To: The Planning Board for consideration at their Dec. 17th meeting

Re: Washington Mews Project

Issues raised at the November meeting and our responses are as follows:

Sheet No: **16**

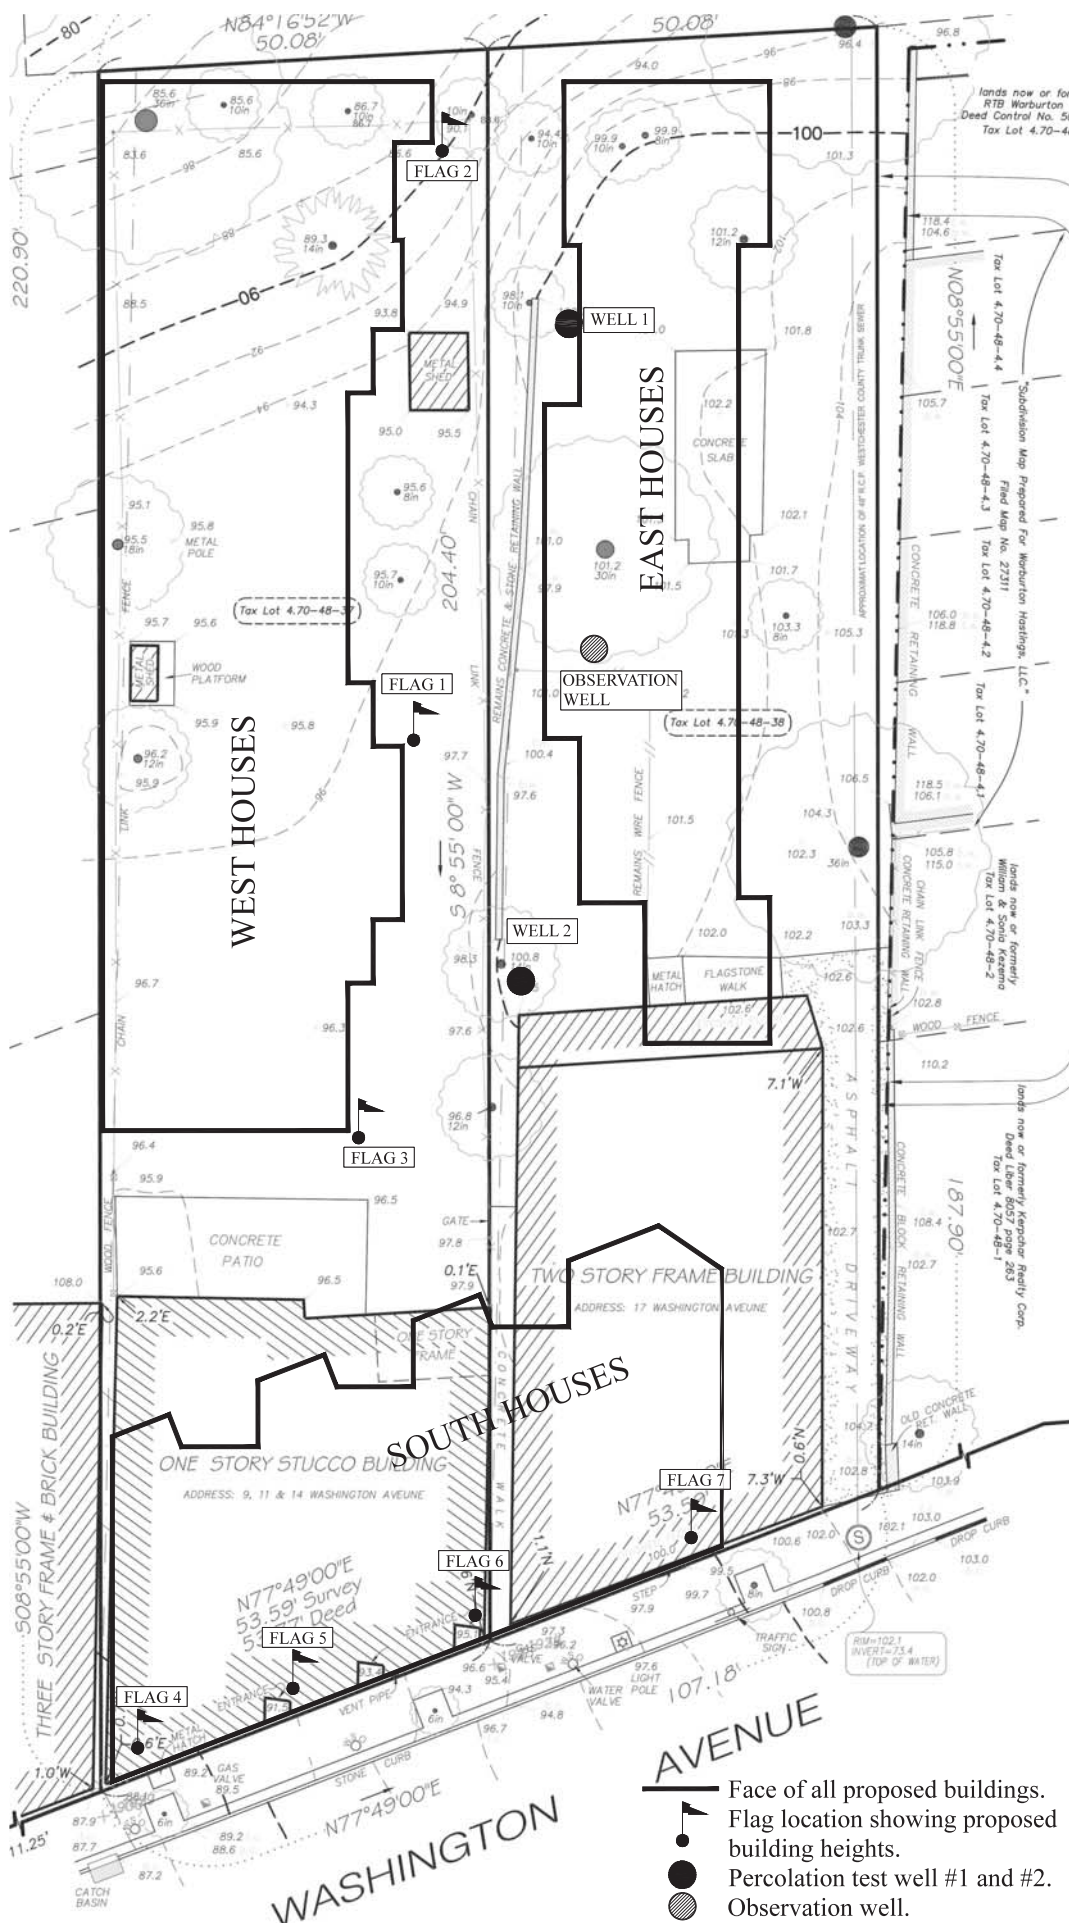
- (3) *Provide detailed drawings of the North Exit way and details of the easement agreement proposed for these facilities*
See new drawing #16 which illustrates all proposed changes on Village property and includes a draft of the essential parts of the proposed easement agreement. We are proposing that a steel stair supported on posts link our pathway which descends 3' along the north P.L. of our site to the +70' grade adjacent to the commuter lot. This in order not to disturb the root systems of the only significant trees on these lands which are adjacent to it. There are two trees immediately north of our proposed building which cannot survive the construction activity. We propose to replace these with 5 new trees which we have shown on the plan.

- (6) *Provide a drawing describing the retaining wall at the NE corner of E-1 and the "fan room" under E-1*
See new drawing #16 and revisions to drawings #1 and #2. This wall projects Only 4' from E-1 as we wish to keep it away from the root system of the very large oak further along on the property line. We wish the existing grades here to be maintained and spill around this short wall. This is illustrated on our north elevation on drawing #7.
